# UNITED STATES PATENT AND TRADEMARK OFFICE

10/811,408

## Office Action Summary

***Claim Rejections - 35 USC § 112***

**FIG. 2**

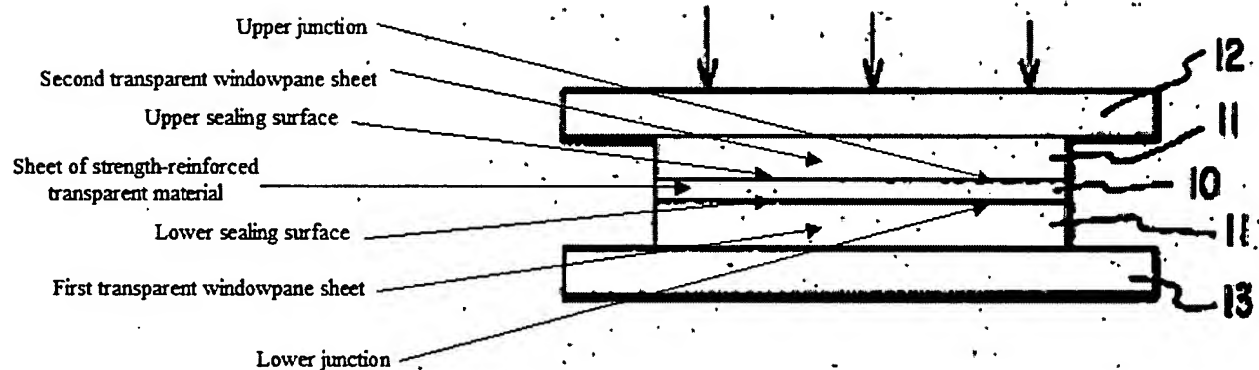
With respect to claim 13 and with particular attention to the reference figure 2 annotated to reflect the applicants chosen lexicon, Martin teaches the following;

1. Providing a sheet of devitrified glass (Column 4, Lines 41- 52) or a "sheet of strength-reinforced transparent material" with upper and lower sealing surfaces as indicated in the figure.

2. Providing first and second transparent windowpane sheets or "Pre-formed bodies of low expansion glasses" disposed in relation to the sheet of devitrified glass in such manner as to produce an upper junction and a lower junction as claimed

3. Applying a predetermined contact pressure at a predetermined temperature (column 4, lines 11-17) in order to achieve a seal or "a diffusion bond" between the first and second transparent windowpane sheets and the devitrified sheet. It is here noted that due to the laminate structure, the central layer of "strength-reinforced material", which is flanked by and protected by the tow outer layers of windowpane sheet material, would reasonably be expected to be more abrasion resistant than the either of said outer layers.

Regarding Applicants newly added limitations, that the materials of construction for layers 10 and 11 in the Martin reference inherently have a tensile strength an impact resistance, and an environmental resistance. As pointed out in Applicants reply filed April 17, 2007, Martin teaches that in a preferred embodiment the layer (10) comprises a lead borosilicate glass comprising 60 to 80% PbO (Column 2, Lines 46-59). To this end, Thorton teaches "lead oxide has been added to glasses and glazes since ancient times" (pg37) and that "lead additions give excellent (radiation) shielding properties to glass" (pg 39). From at least the Thorton disclosure, it is understood that the PbO containing glass would be expected to present a "significantly greater" environmental resistance at least to x-ray and gamma ray emissions.
